Washington State Board of Registration for Professional Engineers & Land Surveyors

Board Packet Addendum

DRAFT Engineering Report

An Assessment of the Decision To Reject a Tunnel as a Viable Option to Replace the I-5 Bridge Over the Columbia River

Figure 3. Columbia River Navigation Channels

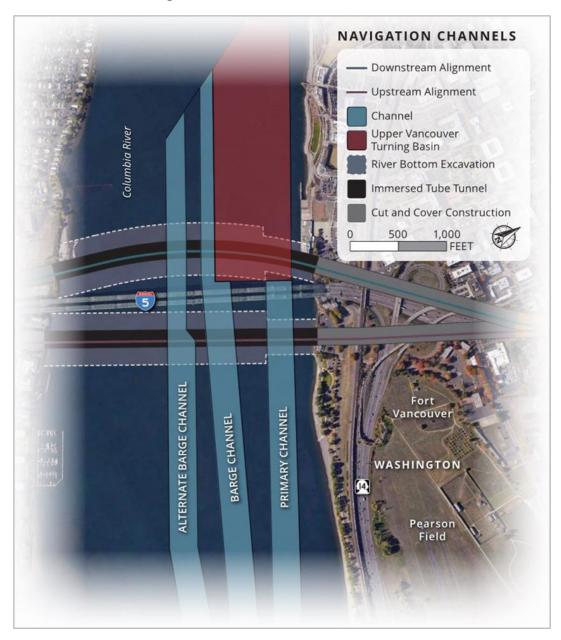
- 1. As shown on the attached Figure 3 from the <u>Tunnel Concept Assessment</u>, there are currently three navigation channels crossing the potential alignments of the tunnel, with the Primary Channel being located within close proximity to the north bank of the Columbia River under the lift-span of the bridge. In addition, there are two barge channels located under the two highest spans of the existing bridge to the south.
- 2. As shown on the attached Figure 4 from the <u>Tunnel Concept Assessment</u>, the low point of the tunnel was assumed to be below the Primary Channel near the north bank of the Columbia. By erroneously assuming that the Primary Channel would not be relocated, the low point of the tunnel is approximately 100 feet below the north bank of the river.

3. If a tunnel were to be constructed, regardless of its depth, it is logical to assume that the three channels would be combined into a single channel in the middle of the river. That "Primary Channel" is currently maintained through the entire length of the Columbia River except at bridges where multiple channels are needed to avoid bridge piers. A credible (no errors) conceptual tunnel design would have assumed that the channel would be relocated to the center of the river. Doing so would have put the low point of the tunnel near the center of the river instead of near the north bank. By sloping the tunnel up from the center of the river to the riverbanks, the tunnel would be much higher in elevation at its banks and inland. Instead of the tunnel being 90 feet deep at the north bank (Vancouver) as was assumed in the flawed DOT conceptual design, it would be about 45-feet deep.

In short, by failing to make the <u>logical assumption</u> that the Primary Channel would be relocated to the center of the river, the tunnel was conceptually designed to be much deeper than necessary where it touches upon land on both sides of the river. In essence, this was a "tunnel too deep" error.

Figure 4. Navigation Channel for the Downstream Alignment

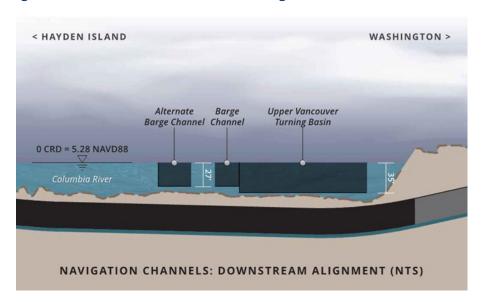
In the <u>Tunnel Concept Assessment</u> referred to above, a conceptual design error was made with the end result being that the tunnel was assumed to be much deeper than necessary. This was a result of the failure to assume that the main navigation channel would be relocated from its existing location near the north bank of the Columbia to the center of the river. To understand this, please note:
